MEMORANDUM

SUBJECT: INFORMATION FOR DOCKET ITEM #11 – Development Special Use Permit #2021-10019 - 760 John Carlyle Street, 1700 & 1800 Eisenhower Avenue, 800 Bartholomew Street - Eisenhower East Block 32 / Carlyle Plaza Two Amendment

This memorandum is provided to amend the staff report text, conditions, and attachments for Development Special Use Permit (DSUP) to reflect changes in the overall project phasing, the maximum building footprints, fix a typo in the staff report regarding land uses, and changes to other various conditions and attachments based on recent conversations with the applicant team.

*Revised Phasing Diagram*

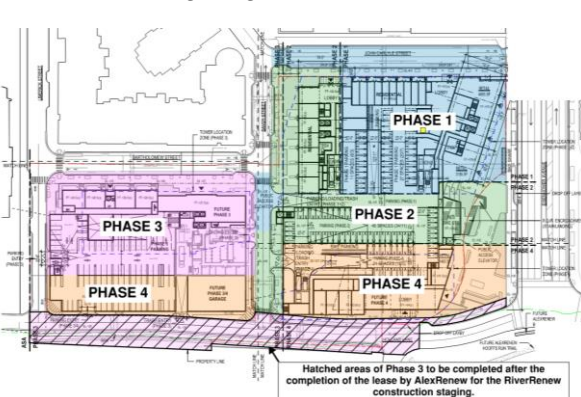
Staff has updated the proposed phasing diagram in Figure #3a “General Phasing” and Attachment #4 to reflect recent discussions with the applicant. Staff and the applicant have agreed that the construction of Holland Lane and the Holland Lane bike trail may be provided with either Phase 3 or Phase 4 of construction, whichever comes first.

*Attachment 2B. Proposed Max. Building Footprints*

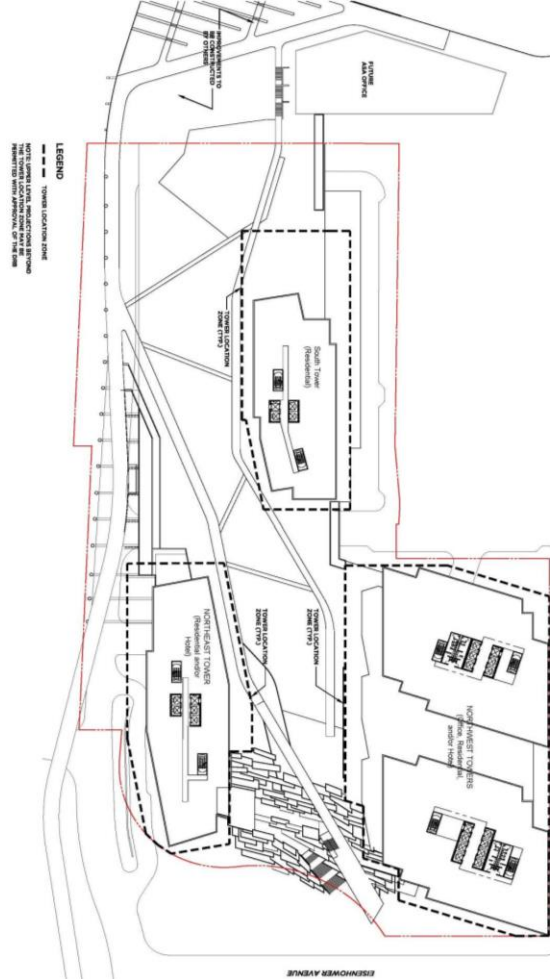
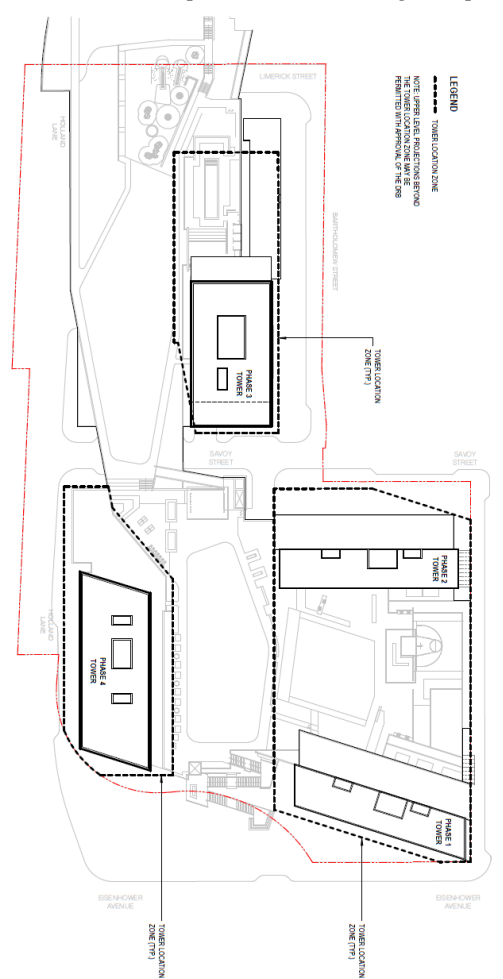
The applicant has modified the maximum footprint diagram approved with DSUP #2013-0025 to accommodate the building footprints proposed with this amendment. The Phase 1 tower footprint requires a minor adjustment to remove a jog in the line to accommodate the design proposed. Further, the Phase 4 tower footprint has been reduced to accommodate the expansion of the open space deck. The Phase 2 and Phase 3 tower footprints remain unchanged. Staff has therefore added Attachment 2B to the staff report to illustrate the revised footprints and has made changes to condition #11 and #34 to reference the correct attachment.
